TITLE <u>REPAIR SCHEME</u> <u>FIRE EXTINGUISHER CABLE</u>		E.E.P. NO. 12587		FILE CODE 111-83
EFFECTIVE IMMEDIATELY		DWG. NO. 111-83003 B		COPIES TO NO.
PART NO. UNK		PART NAME FIRE EXTINGUISHER CABLE		NO.
USE OF E.E.P.		DISPOSITION OF STOCK		NO.
SAVAGE	<input checked="" type="checkbox"/>	ORDER BLOCKS AFFECTED	NOT AFFECTED	3
CONCESSION		USE TO EXPLANATION	REWORK	6
STOP ORDER/RELEASE		AS ORDERED		9
NEW DRAWING		ORIGINATED BY BREWSTER		2
REVISED DRAWING		CUSTOMER RCAF		2
TERMINATION		TYPE AIRCRAFT EXPEDITE 3		1
COMPLETE NOTICE		AIRCRAFT REGISTRATION NO.		3
NOTE AS NOTED		DATE 2 APR 58		1
APPROVED		DATE		DWG. CHANGE
<i>[Signature]</i>		2 APR 58		YES NO
ENGINEER (I)		CONTRACTS ADMIN.		DWG. CONT.
<i>[Signature]</i>		<i>[Signature]</i>		4
GIVE FULL PARTICULARS AND SKETCH WHERE POSSIBLE		CUSTOMER		
		<i>[Signature]</i>

FIG 1

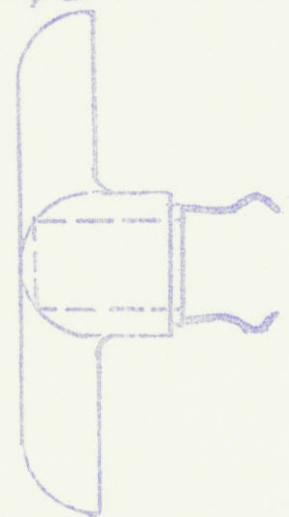
- a) IF THE HANDLE IS OF THE TYPE SHOWN IN FIG 1, THE CABLE IS TO BE REPLACED IAW DWG 111-83003,
- b) IF THE HANDLE IS OF THE TYPE SHOWN IN FIG 2, THE CABLE IS TO BE REPLACED AS SHOWN IN FIG. 3, THE LENGTH OF THE TO BE 43", EXACT LENGTH BEING DETERMINED UPON ASSEMBLY.
